## DEPARTMENT OF PLANNING

*Development Assessment and Systems Performance*

### **SUBJECT: MODIFICATION 5 - DA 77-3-2002 - GEORGE BASS DRIVE, TOMAKIN** **RESIDENTIAL SUBDIVISION "BARLINGS BEACH"**

Figure 6 – Final Plan of amended subdivision with lot changes along the northern boundary to the northern conservation area

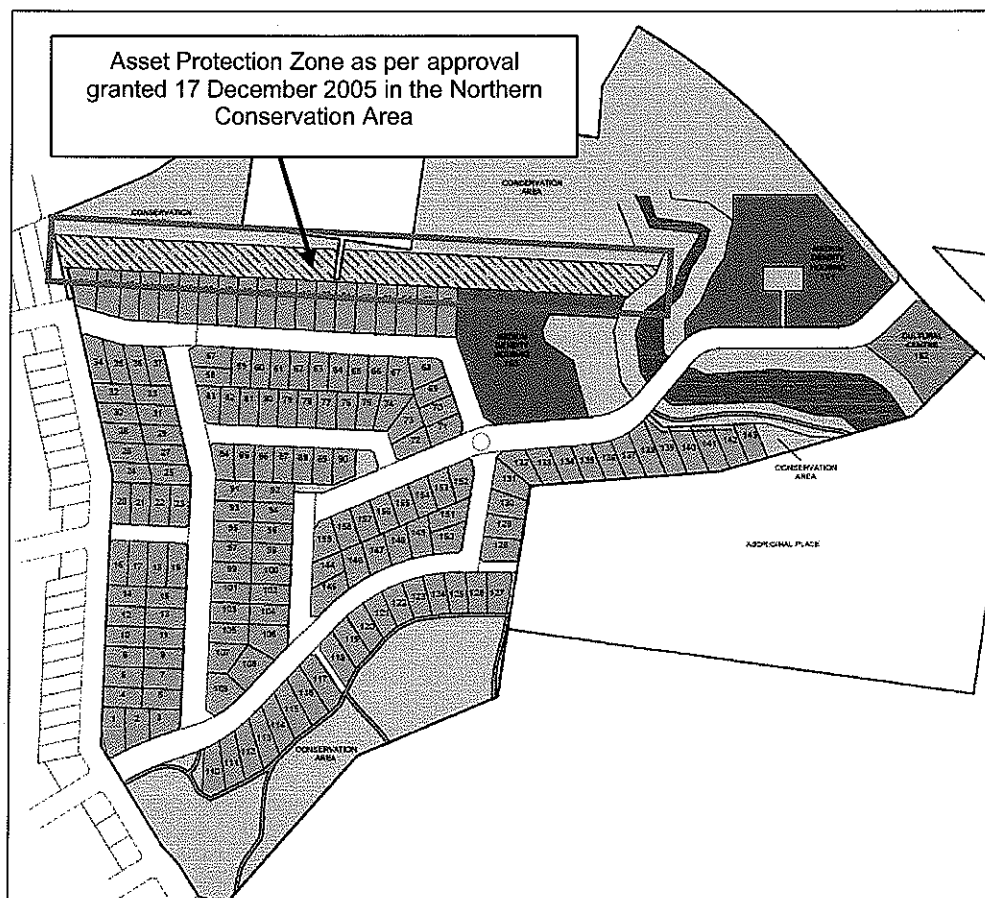
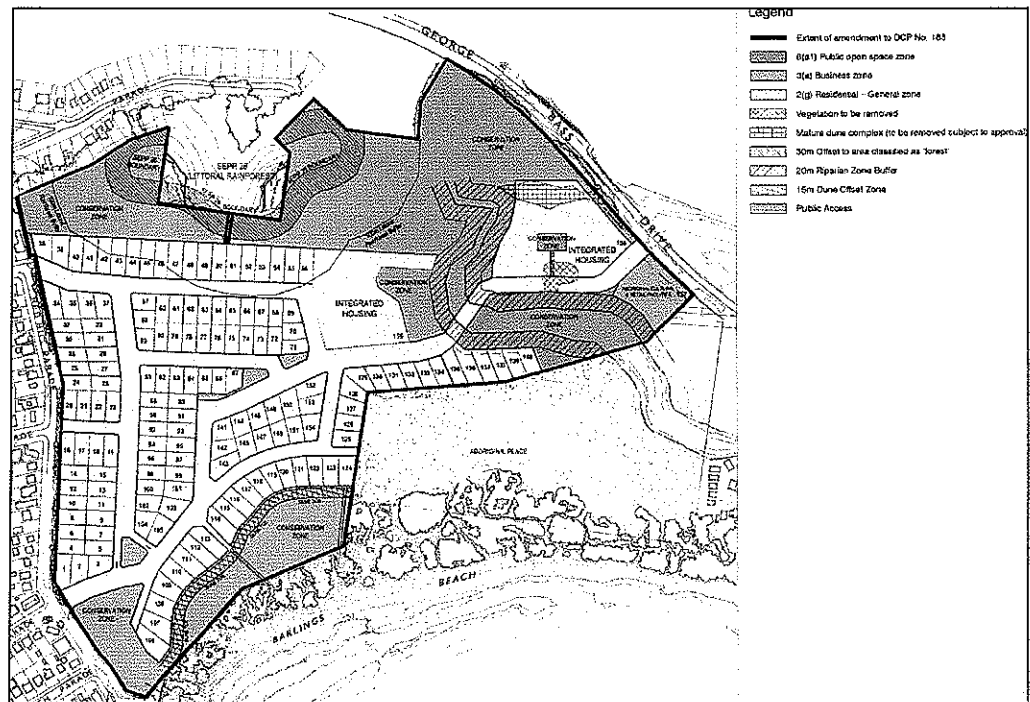
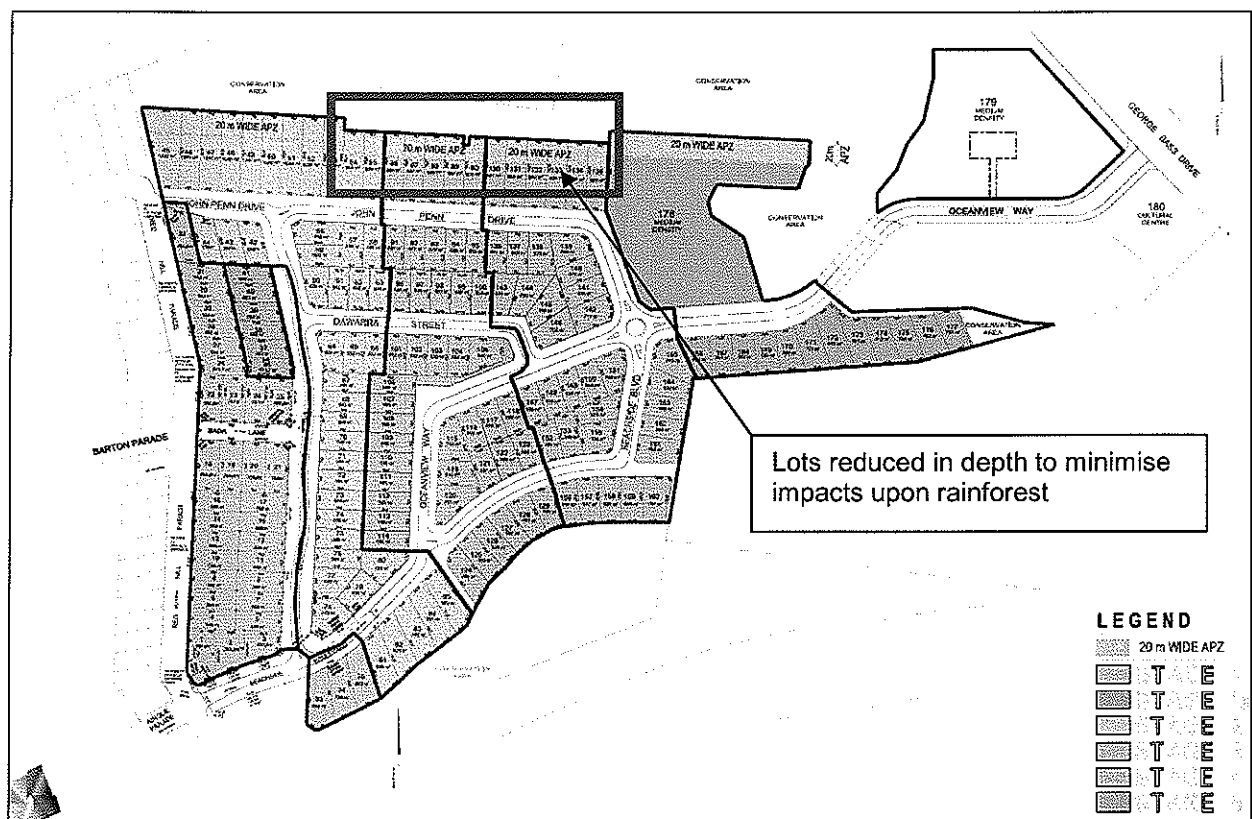
The original approval incorporated a 30m deep Asset Protection Zone (APZ) (refer to Fig 4) within the northern conservation area. The application (as submitted) proposed to increase the depths of the lots adjoining the northern conservation area to incorporate the APZ.

The lots proposed to be modified are in the vicinity of a rainforest identified by *State Environmental Planning Policy 26 – Littoral Rainforest* (Rainforest) (refer Fig 5). The vegetation at the base of the escarpment provides a buffer, protecting the rainforest from onshore winds, which enables this community to maintain certain moisture levels, and its species composition.

The Department was concerned that the clearing of the individual allotments beyond the minimum clearing requirements for the APZs, could remove the 'protective' barrier of vegetation for the rainforest and requested that the applicant increase the buffer to the rainforest. The applicant responded by decreasing the depths of the affected lots (refer to Fig 6).

| <p>There is some concern regarding the viability of the SEPP 26 Littoral Rainforest, given that the vegetation at the base of the escarpment (currently approved to form part of the northern conservation area), which includes coastal Banksia/Eucalypt forest— provides protection to the rainforest from onshore winds.</p> <p>Removal of vegetation at the base of the escarpment for APZ purposes has the potential to remove the "protective" function of the vegetation, and may lead to changes to the composition and quality of the SEPP 26 Littoral Rainforest. A drier type of vegetation on the slope would be more susceptible to fire, endangering the houses on the top of the escarpment.</p> <p>It is considered that to provide an adequate buffer to the SEPP 26 vegetation, that "new" allotments 54 to 135 be reduced in length by a further 10 metres. Please submit amended plans identifying this.</p> | <p>The land has an approval for a 30m APZ within the northern conservation area. The submitted application reduces the land affected by the approved APZ by 10m and thereby increases the extent of undisturbed flora in the northern Conservation Area.</p> <p>In addition, following discussion with the Department of Planning, the proposal has been amended to further reduce the land affected by the proposed APZ proposed within the proposed 'new' allotments 54 to 135 by an additional 10m.</p> <p>Further, in response to the matters raised in relation to clearing arising from land designated as an APZ, and following further discussion with the RFS and PPG's bushfire consultant Matt Jones, the extent of the APZ within the allotments has been reduced to 15m. See enclosed amended drawings and letter dated 21 June 2010 from Matt Jones.</p> |

The proposed modification to contain the APZs within individual allotments has resulted in an additional 5697m<sup>2</sup> (approximately) of northern conservation area now remaining unaffected by clearing for APZ purposes.

Given that the subdivision layout has been further amended to address the Department's concerns regarding the Rainforest, and that the location of the APZs will result in less vegetation clearing, and that the land owner has an AHIP applying to the site for management of ACH, it is considered that the incorporation of the APZ into private allotments is acceptable.

Figure 8: Proposed alignment of John Penn Drive

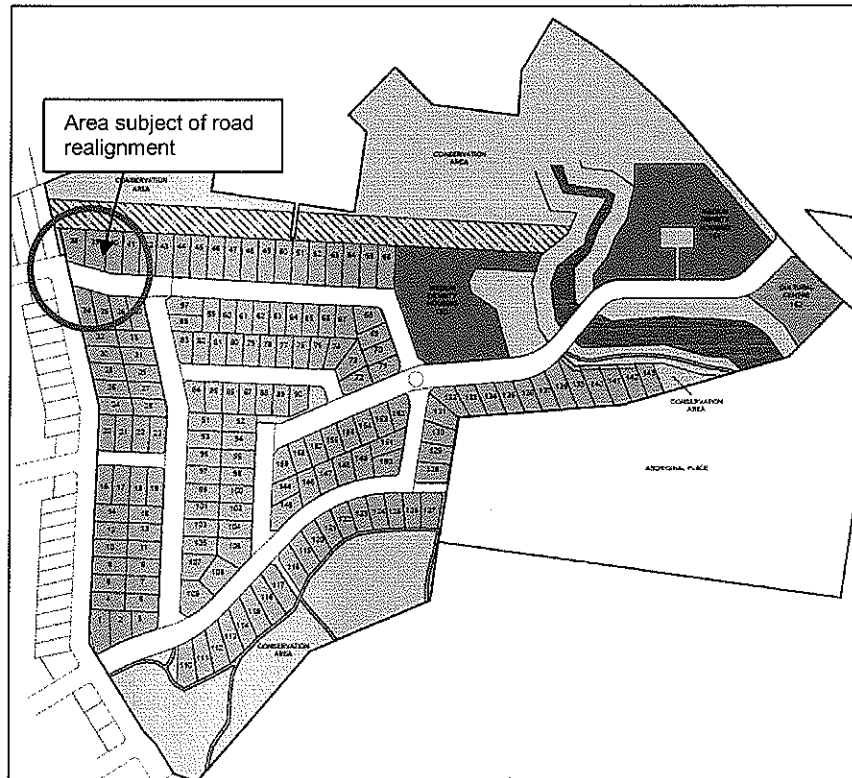
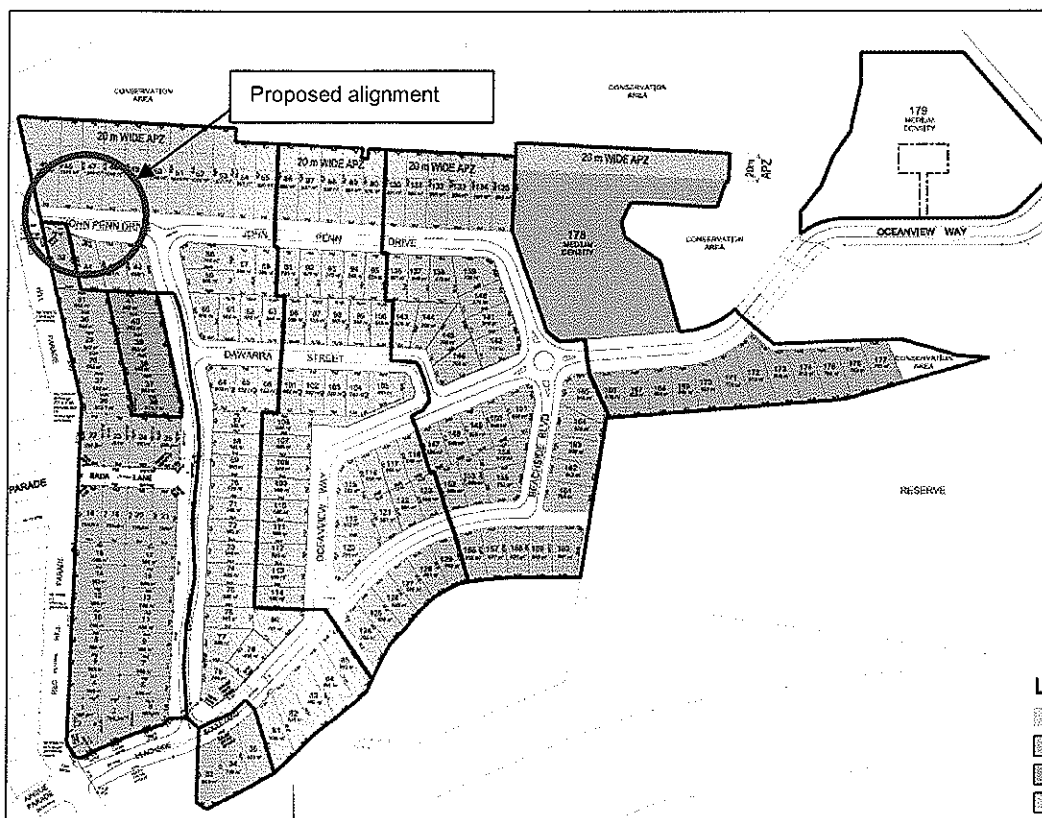
The proposed new road running east west, known as John Penn Drive, will be realigned near the corner of Red Hill Parade. Council has advised the applicant that 3 main trunk infrastructure items being a 200mm and 250mm water main and a 450mm sewer rising main, are located under the approved road (refer to Fig 7). The applicant proposes to realign the road, so that the services are not underneath the carriageway, in order to avoid future road closures to John Penn Drive when maintenance of these essential services is required.

The applicant has investigated the potential to move the services, instead of realigning the road, however they have advised that *"45° and 90° bends would be required as part of the design. This would impact on the integrity of the pipes due to their age and the fact that new bends could create weak spots which would result in possible leaks and breakages of the pipe system"*. As a result it is considered that the best solution would be to realign the road.

The Department supports the change in road alignment so as to ensure orderly development of the site, and for ease of future maintenance of services to and within the site.

Figure 9: Area of Aboriginal Cultural Heritage investigation with "Zones of significance"  
(Source Matthew Barber May 2003)

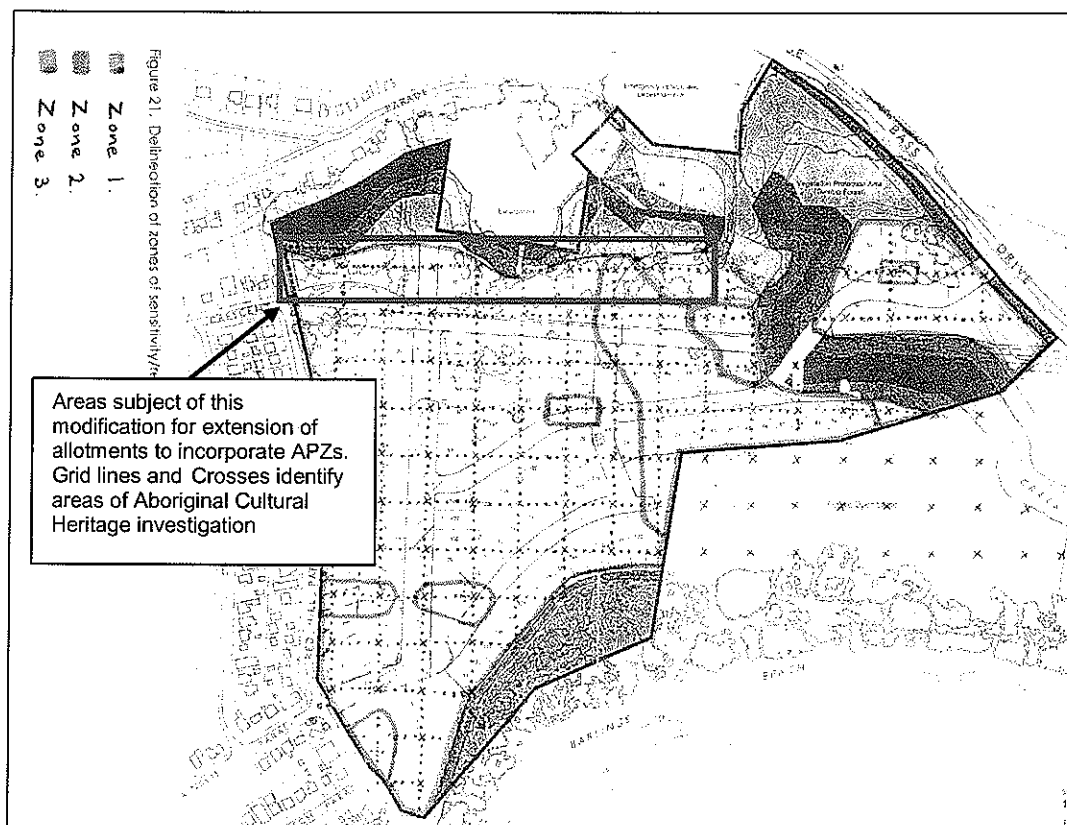
DECCW originally had concerns that the AHIP did not cover the area of the Northern Conservation Reserve and therefore they did not support the extension of the lots into this area as any impacts upon Aboriginal Cultural Heritage had not been assessed in the past.

It is noted that several supporting ACH reports were submitted with the original DA. The areas to the rear of the lots to be extended into the Northern Conservation area have been investigated for the occurrence of ACH artefacts and significance. A report by Southern Cross Heritage Surveys (Matthew Barber, May 2003), indicates that the subject areas affected by this current modification have been investigated and have a low area of significance in terms of ACH. See Figure 9 below.

The lots proposed to be extended to incorporate APZs are in Zone 1 (see Figure 9 above), which has a "low" potential for archaeological significance and, where Zone 3 has a "high" potential. Table 1 below describes the ACH potential; this should be read in conjunction with Figure 9.

The Department is satisfied that based on a review of previously submitted reports and a review of the AHIP that the extension of the lots is acceptable, and that adequate assessment of the impacts of the development upon ACH has been completed.

It should be noted though that after further liaison between the Department and DECCW, DECCW have advised that they have undertaken further investigation into the bounds of the AHIP, and that they consider that the AHIP applies to the entire site, including the northern conservation area, and that they no longer have concerns regarding ACH.
